PROPOSAL FOR DRAFT AMENDMENTS TO DRAFT GTR ON HEAD RESTRAINTS

Transmitted by the expert from the Netherlands

Figure – Demonstrating the ineffective part of head restraint

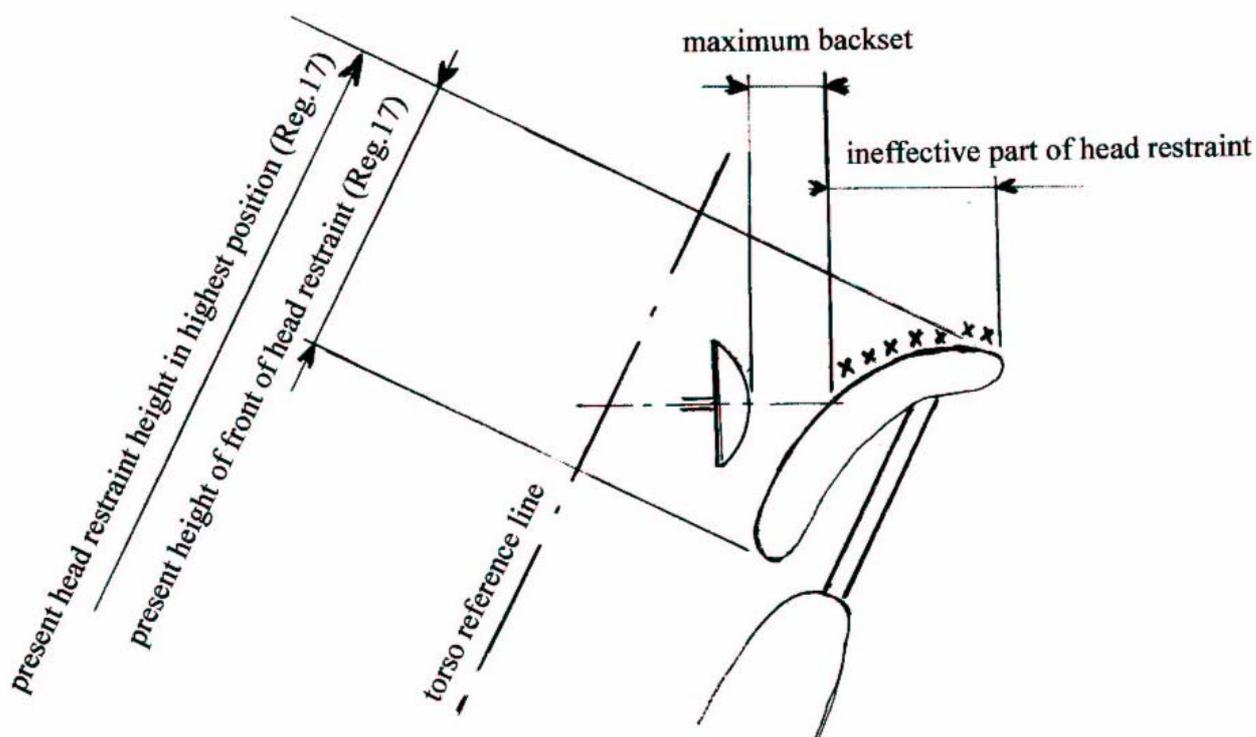
The present definitions of minimum required head restraint height and minimum height of the front of a head restraint seem to be insufficient because certain head restraint shapes are such that a part of the head restraint will not properly function in limiting the rearward displacement of the seated occupant's head. This is clearly demonstrated by the section indicated with crosses on the head restraint in the figure below.

To fulfil this new requirement, head restraints shall be checked on the presence of a minimum Front Contact Surface Head Restraint (100 x 170 mm), which meets two conditions, namely: be close

enough behind the occupant's head according to maximum backset requirement and the top line of this Front Contact Surface (considered as the effective head restraint height, see figure 12-1) should meet the requirements for minimum height above the R-point.

Figure 12-1: Check on compliance of Front Contact Surface Head Restraint to minimum enclosure and location

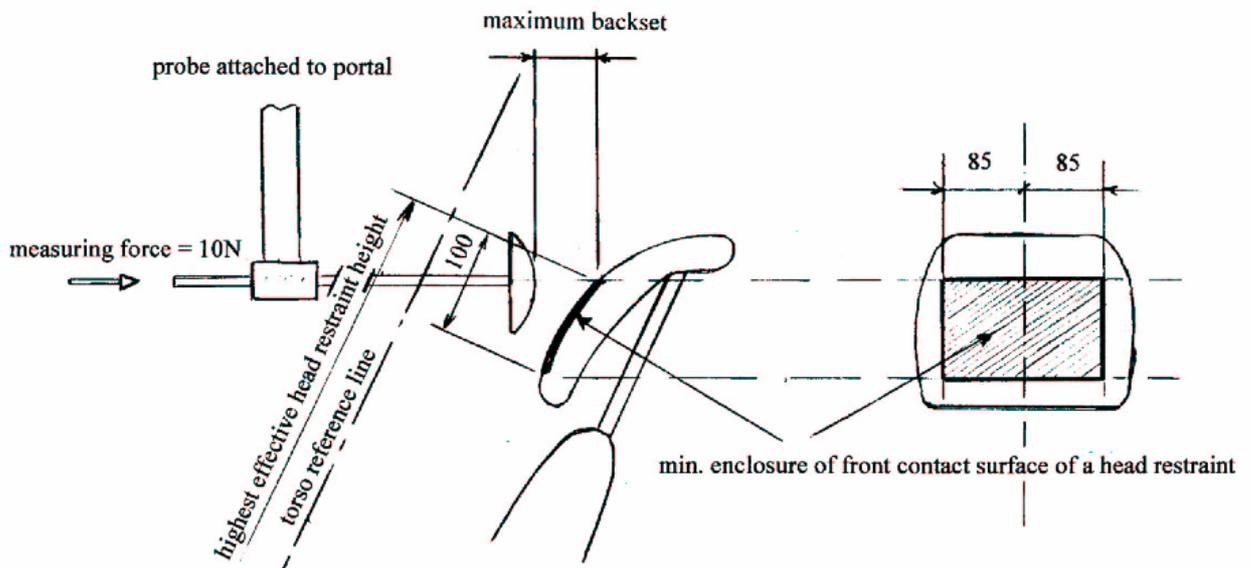
- 3.7. A plane, below and parallel to the plane used to locate the upper border, on a distance of 100 mm (see figure 12-1), shall be used to locate and/or draw the lower border of the Front Contact Surface Head Restraint.
